CONTINUING ELIGIBILITY INSPECTION (CEI) REPORT

FOR FLOOD CONTROL WORKS

Honolulu Engineer District

1. Project Name: Iao Stream FCP
2. Date of Inspection: October 30, 2003
3. Inspection Personnel:

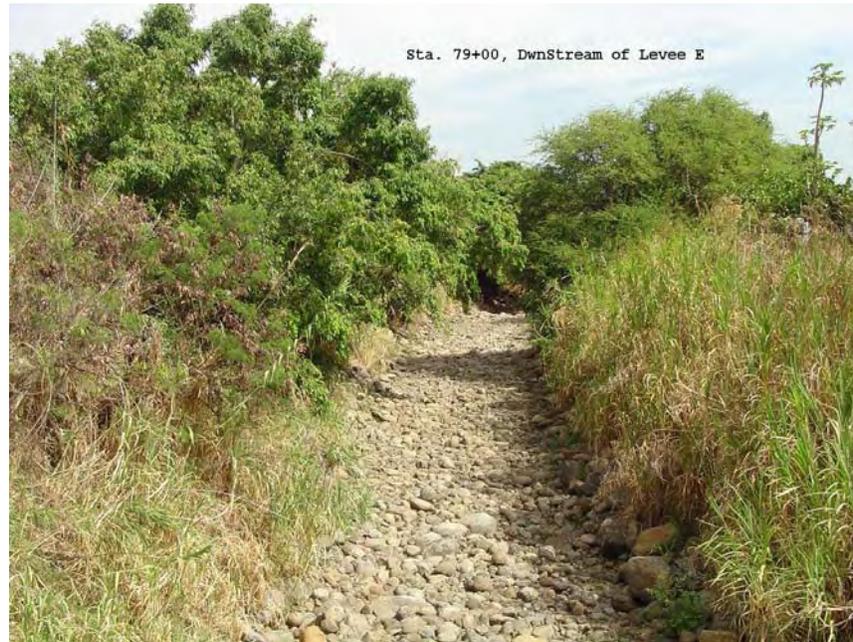
p. Sta. 79+36, RB, the toe of the levee has eroded, continue to stockpile river rocks at the toe, cut vegetation at the top 1/2 of the sideslope.
